| TYPE | YEAR | PROJECT NO. | SHEET NO. |
|---|---|---|---|
| R.O.W. | 2015 | HSIP-106(33) | 29 |
| CONST. | 2017 | HSIP-106(33) | 39 |

CRITZ LANE WILLIAMSON CO.

BEGIN STA. 17+50.00
END STA. 18+00.00

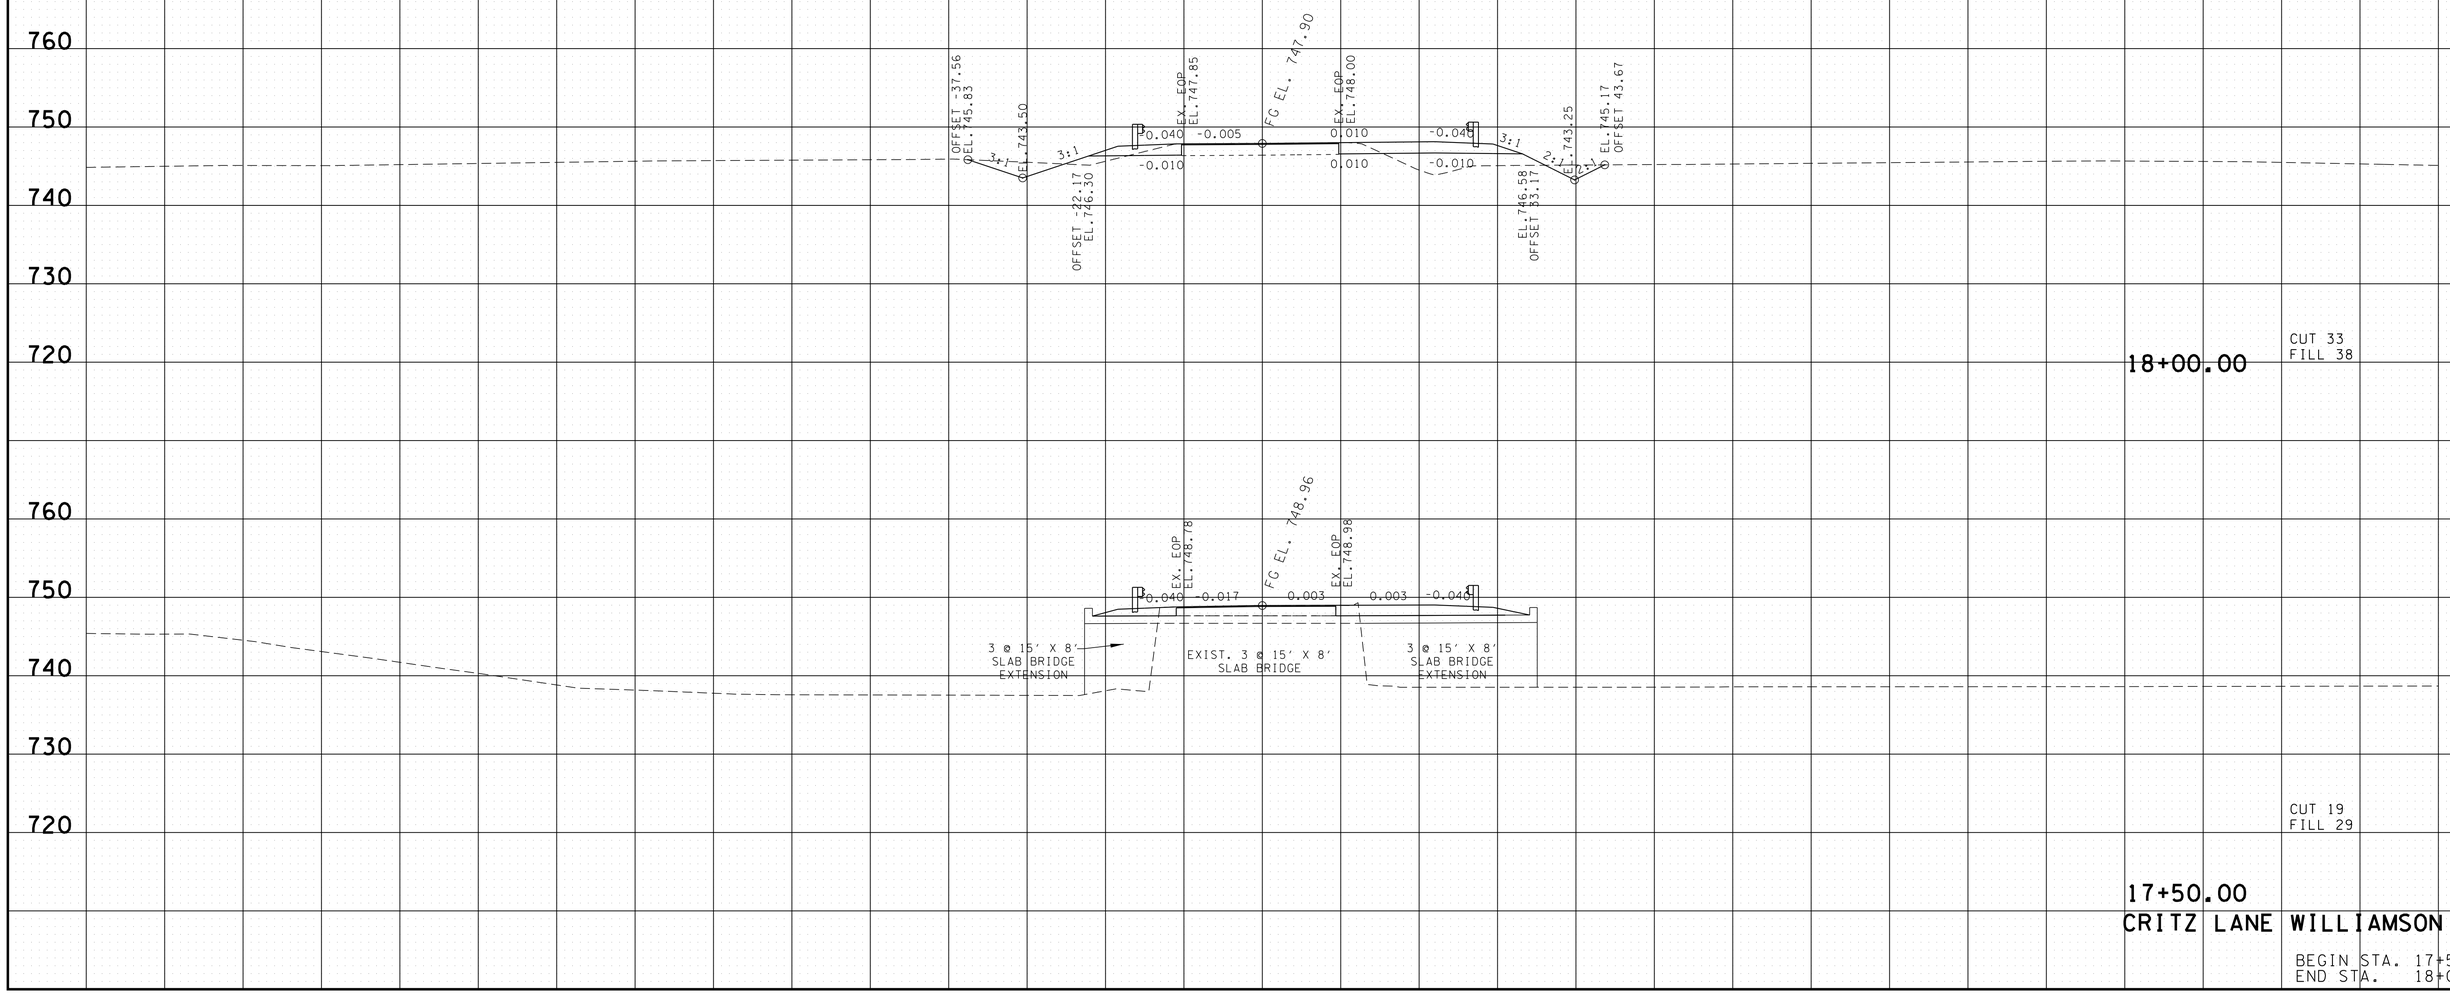
REV. 9-22-16: CHANGED SIDE SLOPE OF DITCHES FROM STA. 18+00 TO 19+50 RT. FROM 3:1 TO 2:1.
